Exhibit A

Revised Plans, dated August 22, 2014, prepared by Shalom Baranes Associates

**DISTRICT OF COLUMBIA
A PLANNED UNIT DEVELOPMENT**

MODIFICATION TO A CONSOLIDATED PLANNED UNIT
DEVELOPMENT APPROVED PURSUANT TO ZONING
COMMISSION CASE NO. 07-26

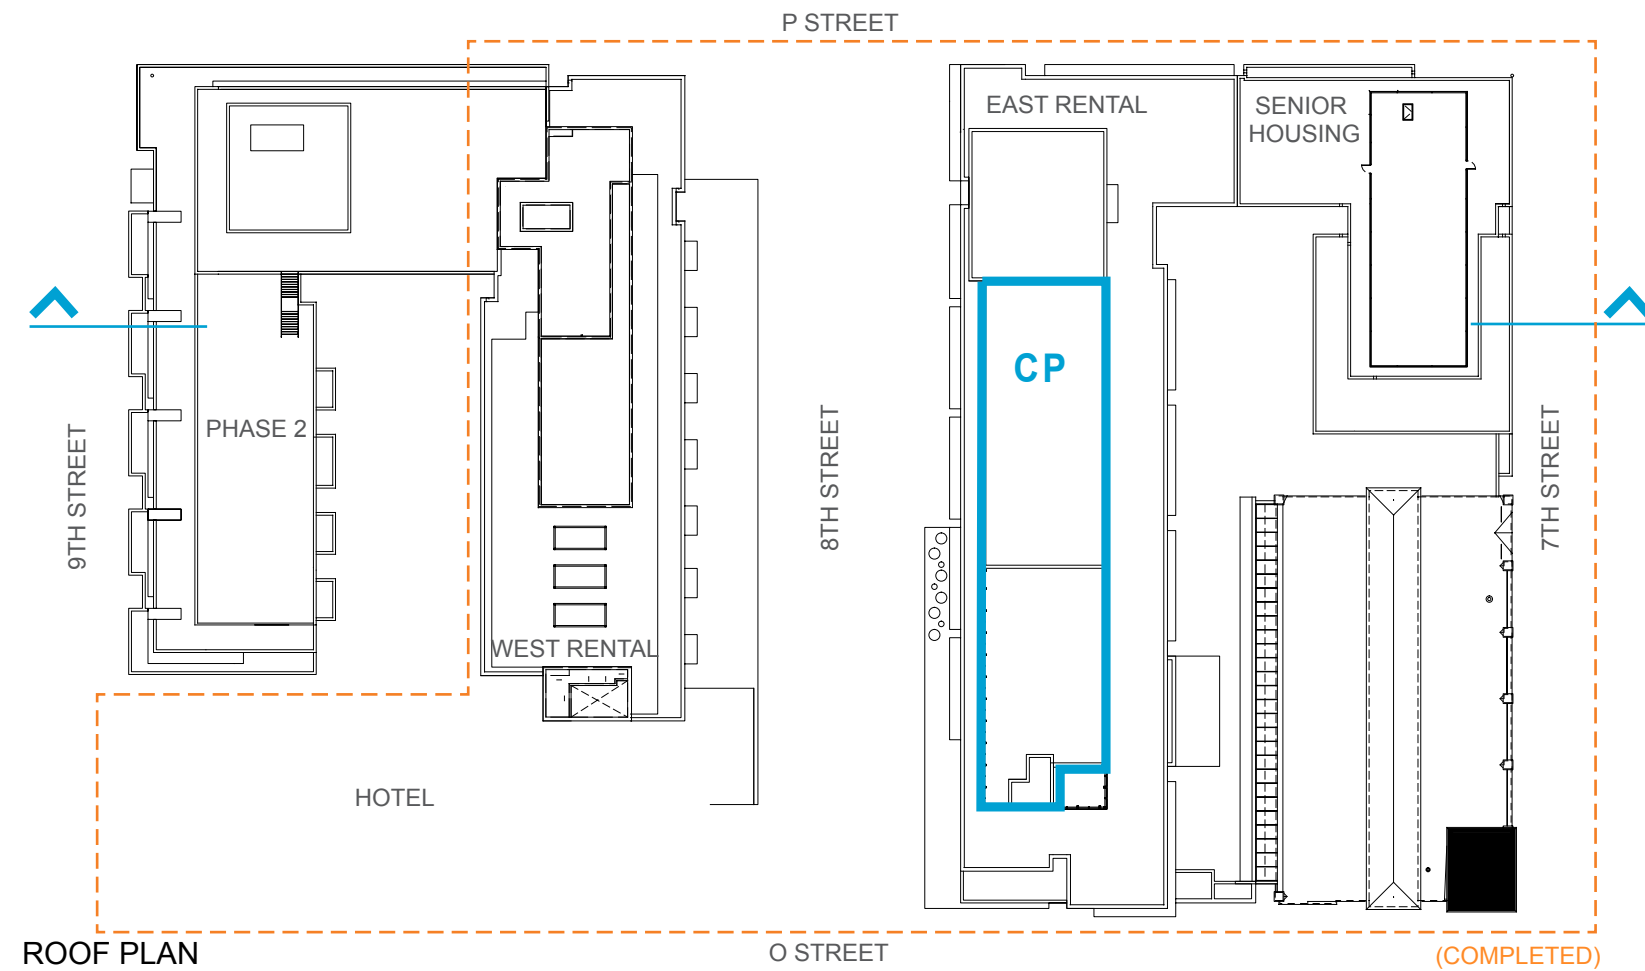
THE CONSOLIDATED CENTRAL PLANT (CP), BUILT IN THE PREVIOUS PHASE, ELIMINATES THE NEED FOR FUTURE MECHANICAL SYSTEMS ON REMAINING ROOFTOPS. HOWEVER, THE DISTANCE BETWEEN THE CENTRALIZED MECHANICAL SYSTEM AND THE FUTURE WEST BUILDING REQUIRES LARGER PIPING OVER TOP FLOOR CEILINGS TO PROPERLY SERVE THE NEW BUILDING SPACES. A 2% HEIGHT INCREASE WILL ACCOMMODATE THE SPACE NEEDED FOR THE LARGER PIPING.

UTILIZING THE CENTRAL PLANT CONSTRUCTED IN PHASE 1 TO SUPPLY UTILITIES FOR THE PROPOSED BUILDING ENABLES PROVISION OF SIGNIFICANT ROOFTOP AMENITY SPACE AND OUTDOOR ACCESS UNINTERRUPTED BY MECHANICAL PROVISIONS.
